Case No. 313220

Re: Proposed SHD development on the Site Incorporating Old Dundrum Shopping Centre known as Old Dundrum Village Centre and Adjacent properties to the west of Main Street, Dundrum, Dublin 14

Fig. 4.2.2 – Lawson Criteria Results at Zone 1 of Proposed Dundrum Development

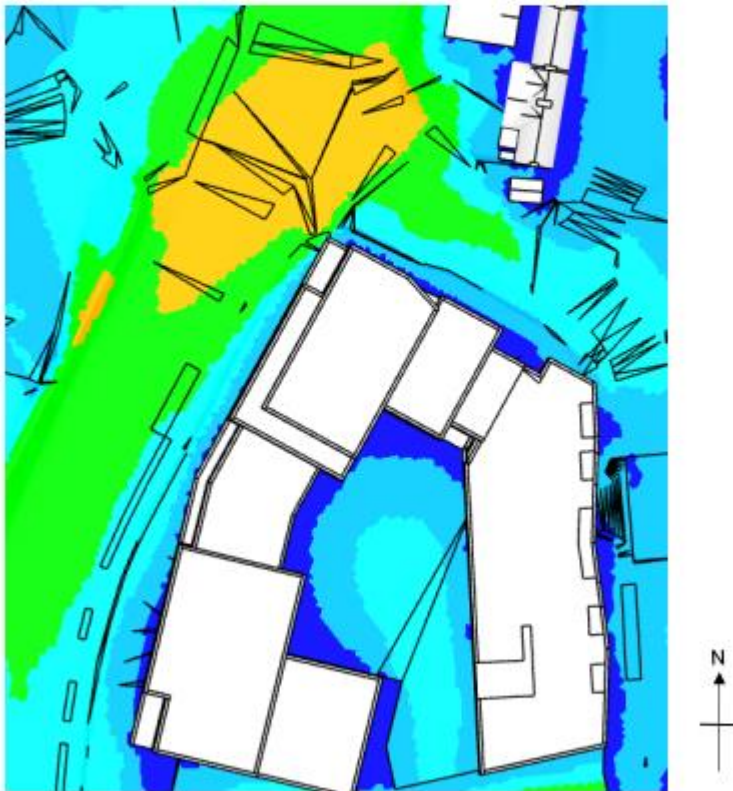
The results of the Micro-Climatic Wind Analysis **are seriously concerning**. The area to the north and west of the 16 storey building will only be suitable for 'Business Walking'. This area is already uncomfortable for pedestrians trying to cross the Dundrum Bypass with accelerated traffic levels. It would also appear to impact upon the very attractive spaces created outside Dundrum Library where a recent public realm initiative by DLRCOCO has taken place where seating and at times, a storybook installation/display, areas have been installed for the enjoyment of local residents. The impacts of the 16 storey building will seriously compromise this much loved and used outdoor public space. No mitigation measures have been proposed by the applicant.

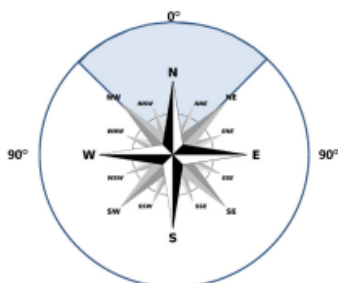
Church Square and the above-mentioned cycle way are somewhat positive features of the scheme. Church Square is an area of semi-useable public open space that is well designed in terms of its relationship with the adjoining café/restaurant uses and the meeting/function room of the adjacent church building with a favourable south-facing. However it experiences severe level changes, is

located to the rear of the church and so is not visible or directly accessible from Dundrum Main Street. It certainly does not fulfil the role of a true civic amenity space/square. The applicant's assertion that this space could accommodate fairgrounds, ice rinks etc. is seriously questioned. The provision of a lift to access the space from Ballinteer Road is indeed far from ideal, as acknowledged by the applicants themselves (Page 7 Landscape Design Statement).
